Re: Technical Evaluation Comments and Information Request #3 for
CES-Mendota Site Underground Injection Control (UIC) Permit Application
Class VI Pre-Construction Permit Application No. R9UIC-CA6-FY20-1

Evaluation of Operating Procedures of the CES-Mendota Permit Application

Evaluation of the AoR Delineation Modeling Approach for CES-Mendota Class VI Permit Application

Model Domain and Tartan Grid

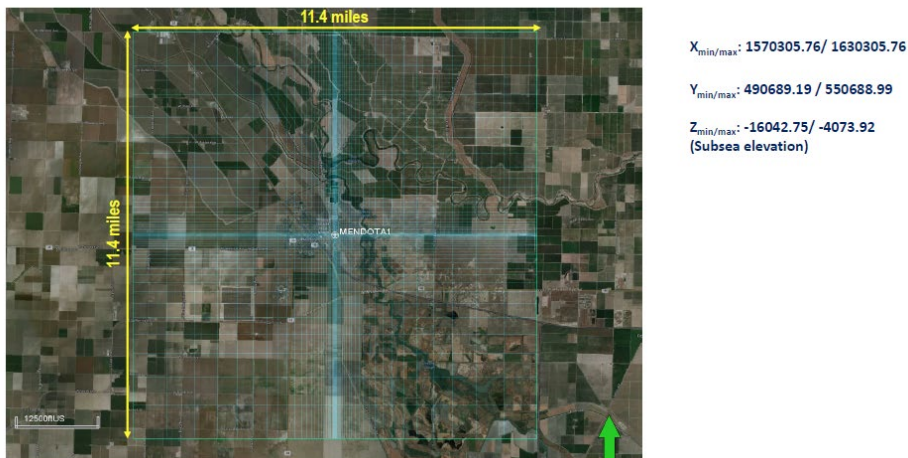
The model domain was generated in Petrel. The static grid for the numerical model is 19 miles by 19 miles in the x and y directions. The part of the domain used for dynamic modeling is 11.4 miles by 11.4 miles in the x and y directions, with a tartan pattern of smaller cell sizes closer to the proposed injection well, as shown in Figure 1 of Attachment B, which is reproduced below.

In the Z direction, the domain includes the Garzas Formation (the first permeable sandstone above the Moreno Shale confining zone) down through the basement. The grid comprises “...53 x 53 x 446 cells (totaling 1,252,814) in the x, y, and z direction, respectively, with variable cell sizes. The smallest grid cells around the injector and observation well are 60 ft x 60 ft laterally. Vertical thickness of each cell within the model depends on the vertical proportion of each formation.”

This approach to discretization appears to be generally appropriate; it is understood that the horizontal grid cell size will be reduced as appropriate based on 3D seismic data to be acquired later in the project.
